Addendum 100 Regulation No. 101

Revision 2 – Amendment 3

Supplement 9 to the original version of the Regulation: Date of entry into force:
19 August 2010

Annex 10, amend to read:

Figure 10/1

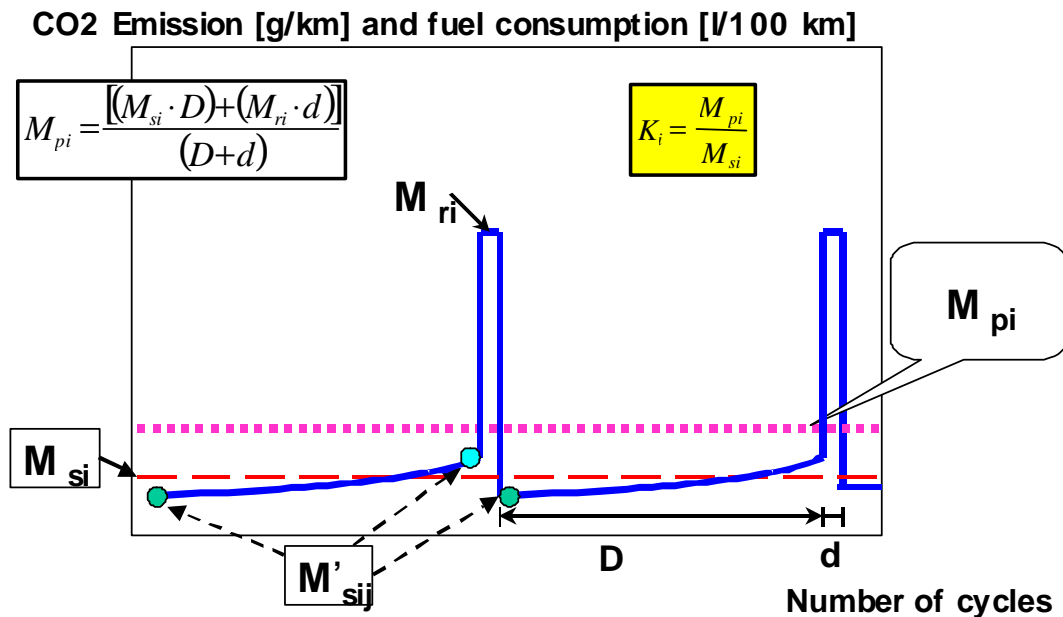
For an illustration of measurement parameters see figure 10/1.

Figures 10/2 and 10/3

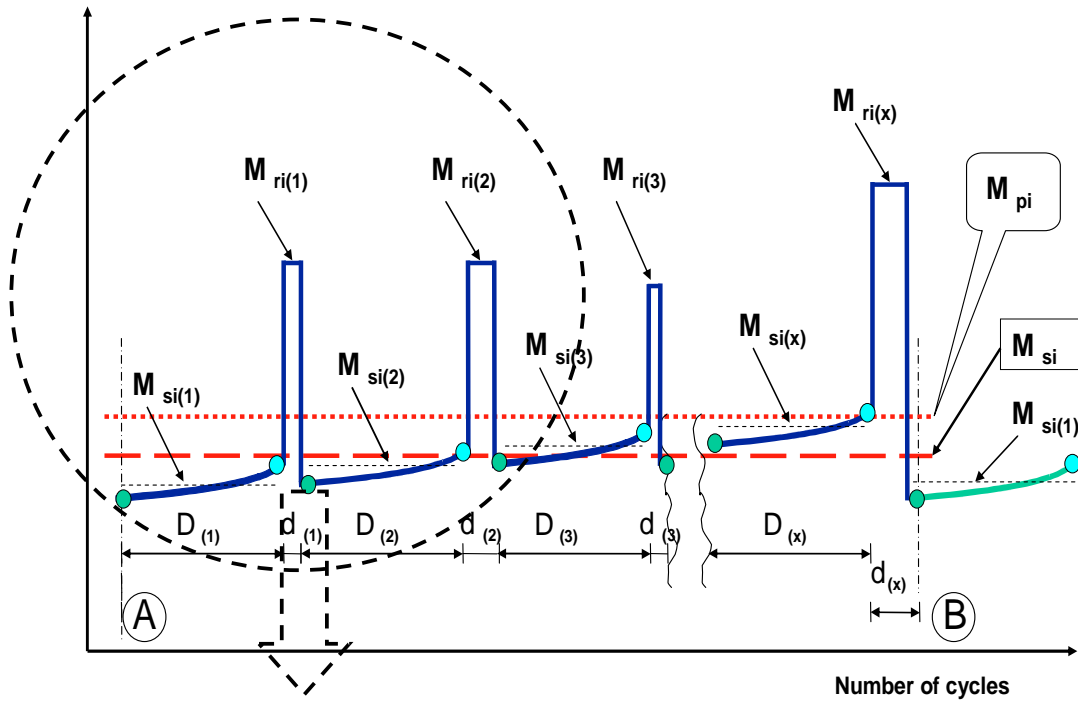
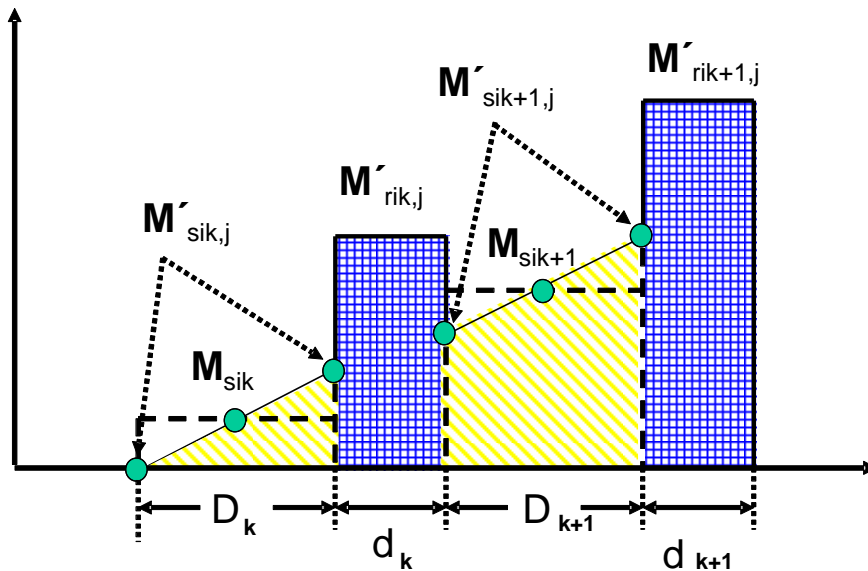
For an illustration of measurement parameters see Figure 10/2 (below)

For more details of the schematic process see Figure 10/3

For application of a simple and realistic case, the following description gives a detailed explanation of the schematic example shown in Figure 10/3 above):

The calculation of the factor (K_i) for multiple periodic regenerating systems is only possible after a certain number of regeneration phases for each system. After performing the complete procedure (A to B, see Figure 10/2), the original starting conditions A should be reached again.
